re: Geotechnical Assessment – Site Servicing Plan Review
Proposed Commercial Development
101A and 103 Schneider Road - Ottawa

file: PG5682-MEMO.03

Site Servicing Plan Review

Figure 1 - Service Pipe Frost Protection Recommendations

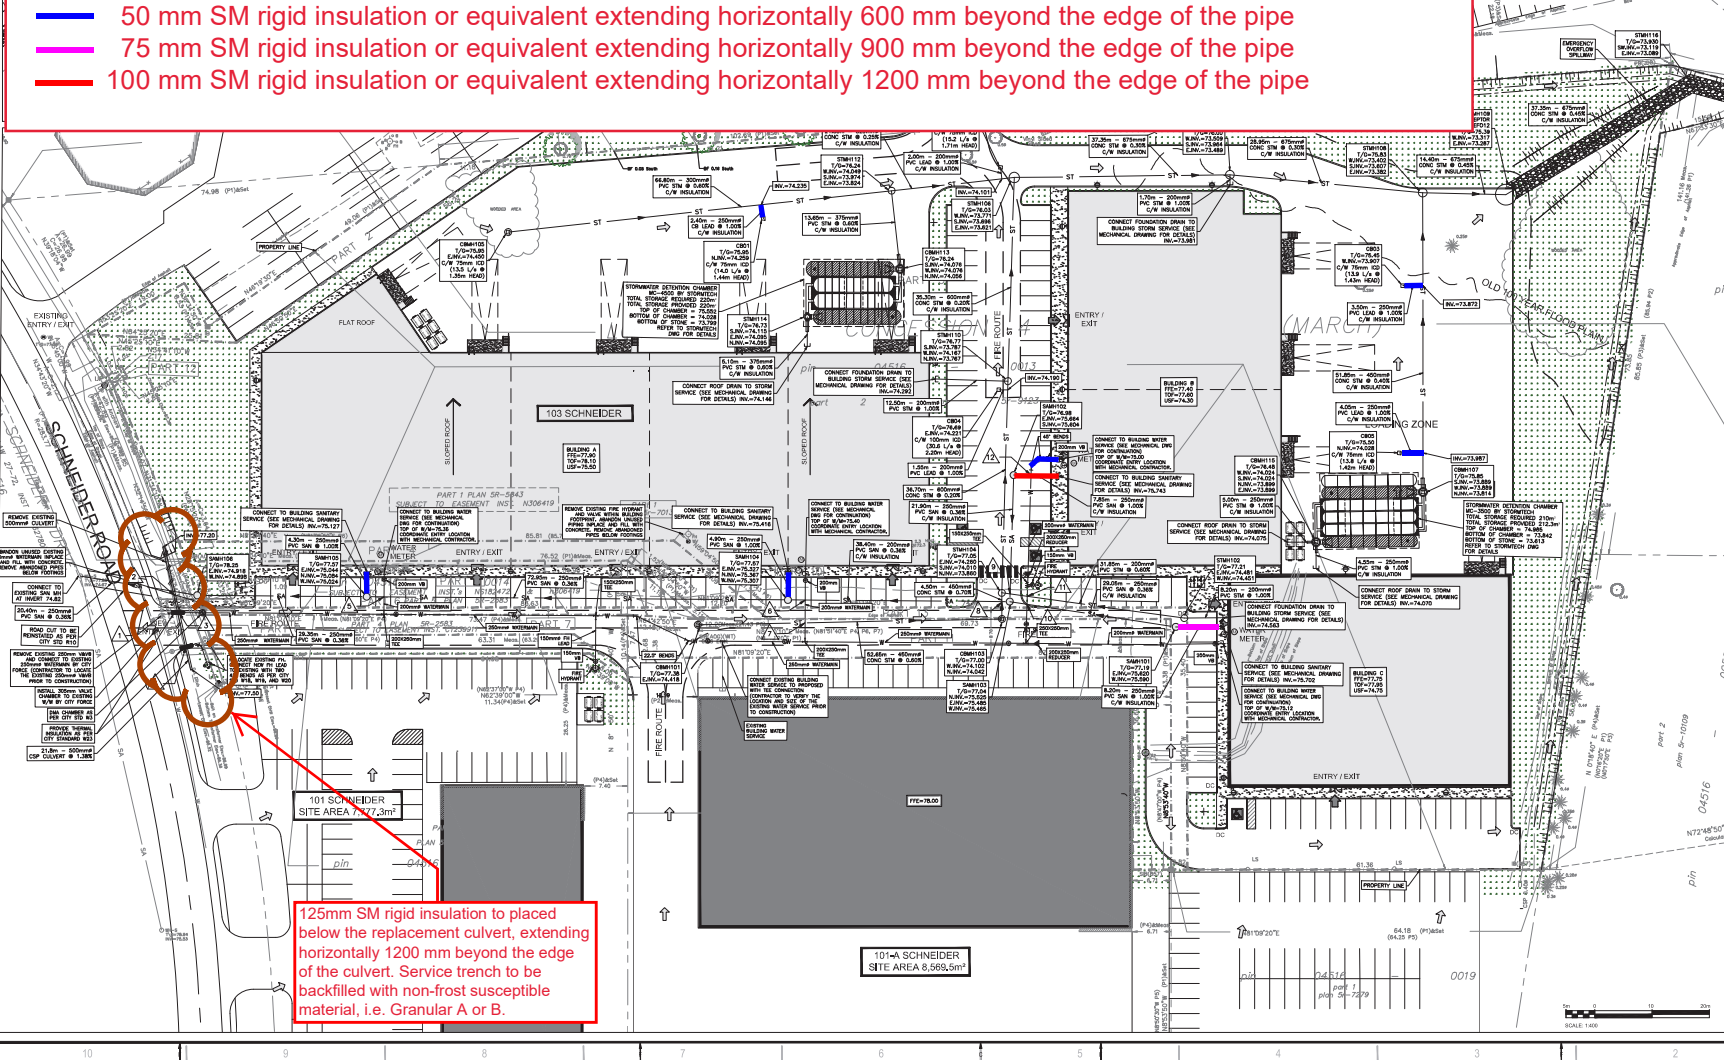
Based on our review of the site servicing plans, the majority of the design details for the proposed development, were found to be acceptable from a geotechnical perspective. However, some of the service pipes along with the proposed culvert were noted to be provided with reduced soil cover to invert level against frost action.

Paterson has reviewed the WSP drawing, and a reduced frost cover was observed for some of the service pipes/structures. Therefore, SM rigid insulation will be required to provide sufficient frost protection for several of these service pipe alignments. Please see below, and marked on the plan, the recommended thickness and extent of the rigid insulation. This figure shall be read in conjunction with Paterson Group Report PG5682-MEMO.03 dated July 14, 2021

It should be noted that SM rigid insulation or equivalent will be required to be placed above the service pipes, with thickness and extent as noted on Figure 1, attached to this memorandum report, in order to provide sufficient frost protection for service pipes. It should also be noted that SM rigid insulation or equivalent will also be required to be placed below the replacement culvert, extending 1200 mm beyond the edge of the culvert from both sides. The service trench for the replacement culvert shall be backfilled with non-frost susceptible material, i.e. granular A or B.

- 50 mm SM rigid insulation or equivalent extending horizontally 600 mm beyond the edge of the pipe
- 75 mm SM rigid insulation or equivalent extending horizontally 900 mm beyond the edge of the pipe
- 100 mm SM rigid insulation or equivalent extending horizontally 1200 mm beyond the edge of the pipe

125mm SM rigid insulation to be placed below the replacement culvert, extending horizontally 1200 mm beyond the edge of the culvert. Service trench to be backfilled with non-frost susceptible material, i.e. Granular A or B.
